Decision Report

North West Treatment Hub

Castle Hill and Rouse Hill Water
Recycling Plants Compliance
Upgrade

January 2022

Figure 1. Indicative location of project changes at Rouse Hill WRP (for details, refer to Appendix B). *Source Map – Nearmap*

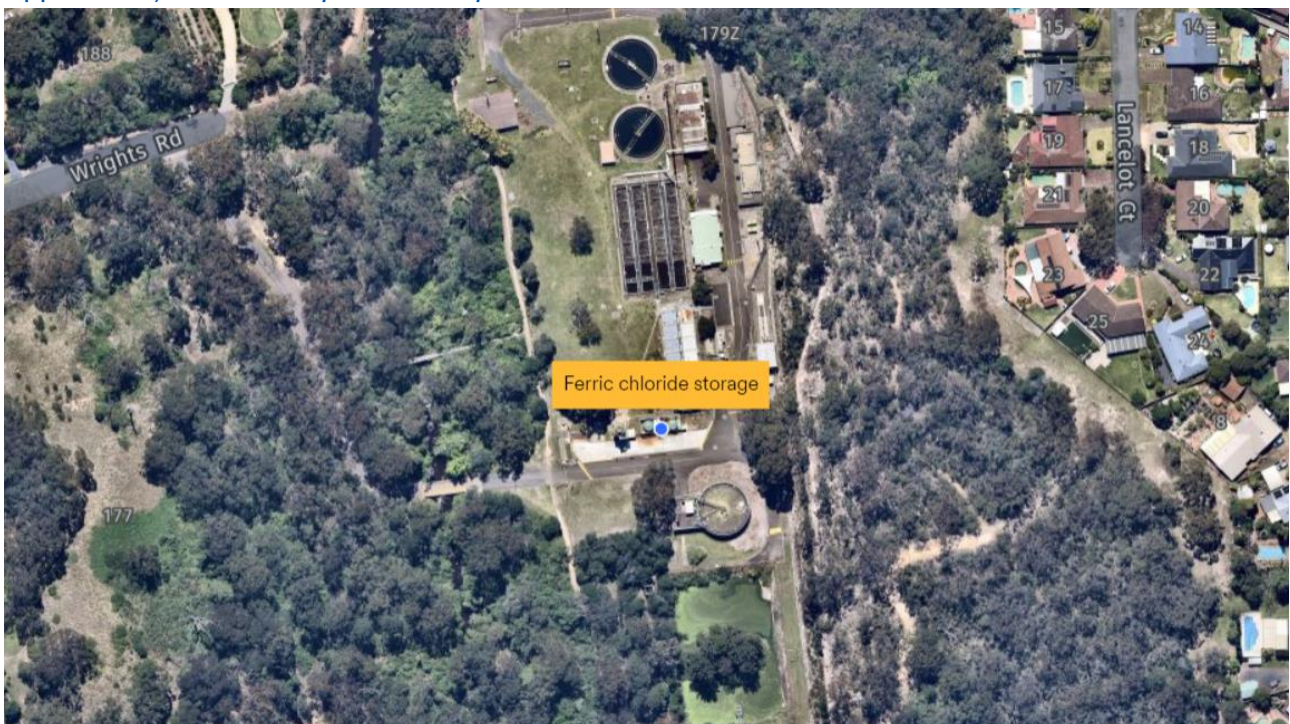
Supplementary assessment		
Scope of changes, justification and location	1. At Rouse Hill WRP, an additional compound area is required – review of the delivery plan identified a shortfall in compound areas available. This will be located within the Rouse Hill WRP.

2. At Rouse Hill WRP, installation of a 15m pipeline section and connection chamber is required – originally this was planned for delivery for the growth package, however, a revised peak wet weather flow rate of 2,305 L/s to 2026 identified a hydraulic restriction requiring this pipeline and connection chamber to be brought forward for delivery during the compliance upgrades.

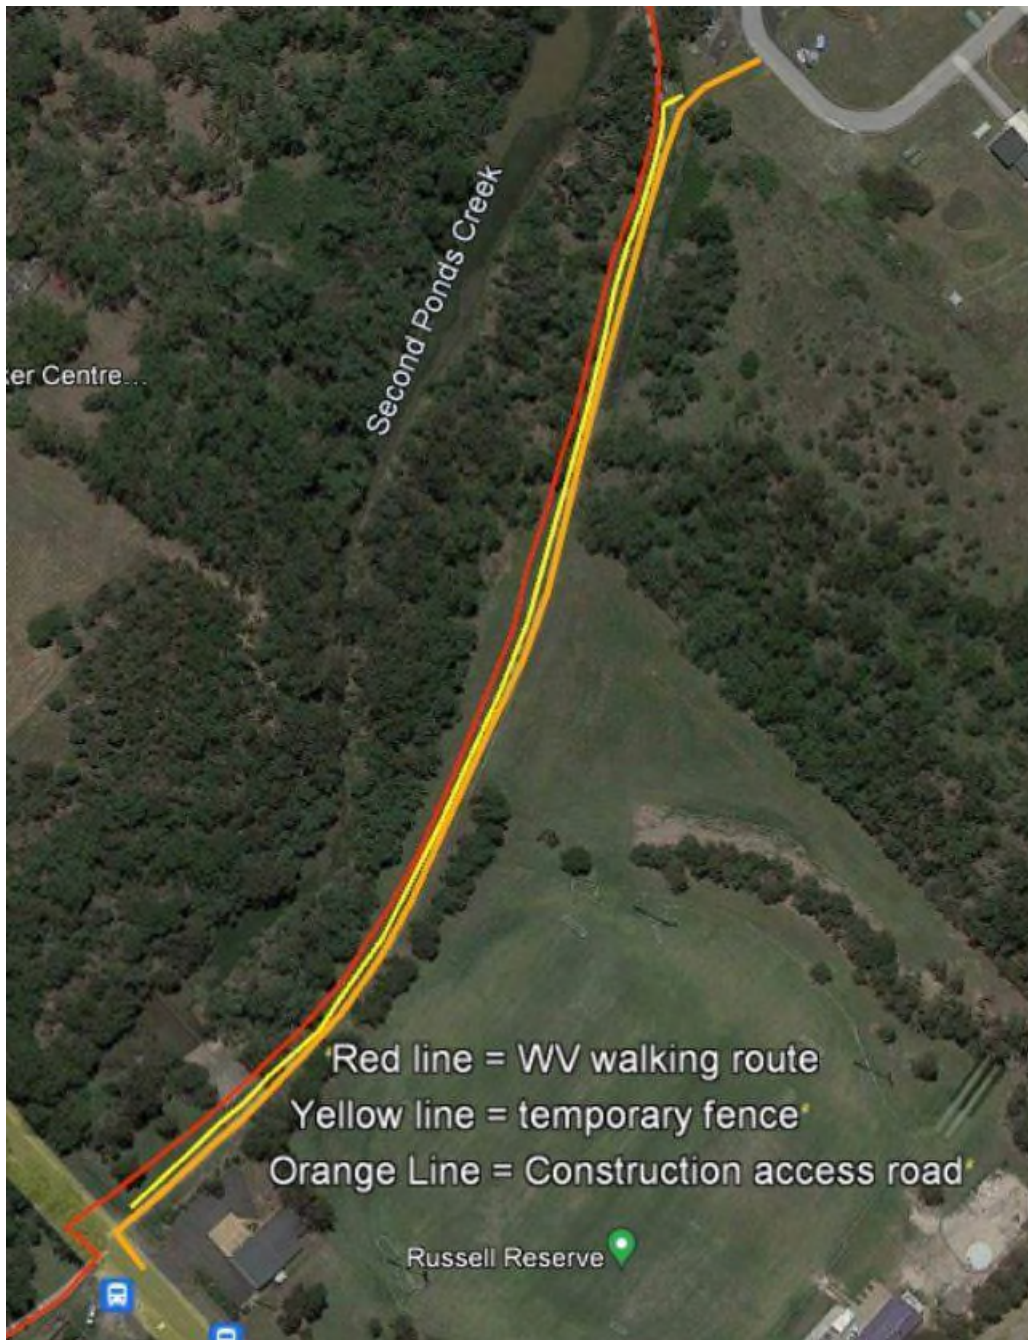
The plan in the Community Newsletter of August 2021 and the REF (see below) shows the use of the maintenance trail from Withers Road to the south-western corner of the WTP as an access road for construction vehicles. The REF also states in section 6.8 that *"Pedestrian access is not permitted via the secondary access road, however, pedestrians were observed using this access road as it is directly adjacent to Russell Reserve."*

We recognise the community value of having access to this walking trail and that this access road to Rouse Hill WRP is visible as a walking route on Google Maps. Sydney Water is aware that members of the public use this road. We are committed to safety first in relation to the users of this access road. During construction, there will be variable light and heavy vehicle movements along this road which will be the main construction access road into and out of the Rouse Hill Water Recycling Plant. Without compromising safety of the community and our personnel, we will continue to engage with The Walking Volunteers during construction planning and use our best

endeavours to find a safe solution such as shared or alternative pedestrian access routes, to maintain connectivity of trail for the community. This will form part of the Traffic and Pedestrian Management Plan.
